Transmittal
Work Plan Addendum
1650 65th Street
Emeryville, California
Fuel Leak Case No. RO0000440
Geotracker Global ID T0600100511

Subject: Work Plan Addendum

1650 65th Street, Emeryville, California Fuel Leak Case No. RO0000440

Revised Proposed Sub-slab Vapor Sampling Locations 1650 65th Street Emeryville, California

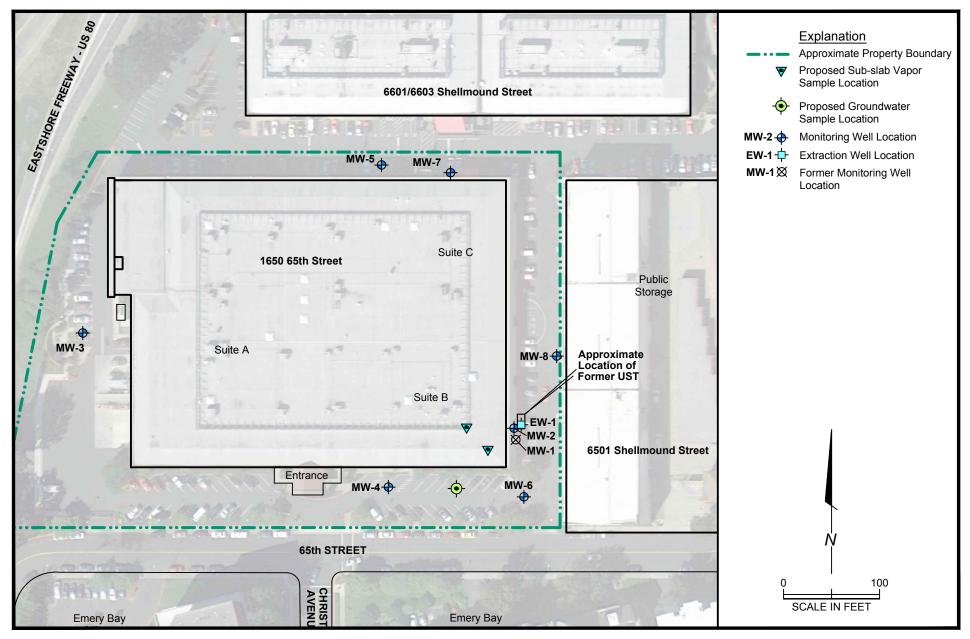
One additional sub-slab vapor sampling location has been added in the southeastern interior corner of the building. The revised proposed permanent sub-slab soil vapor monitoring points are presented on Plate 1. The installation, sample collection, and analyses of the permanent sub-slab vapor points will be in accordance with procedures and methods previously described in the Work Plan, as well as the technical comments provided in the ACEH 2011 Letter.
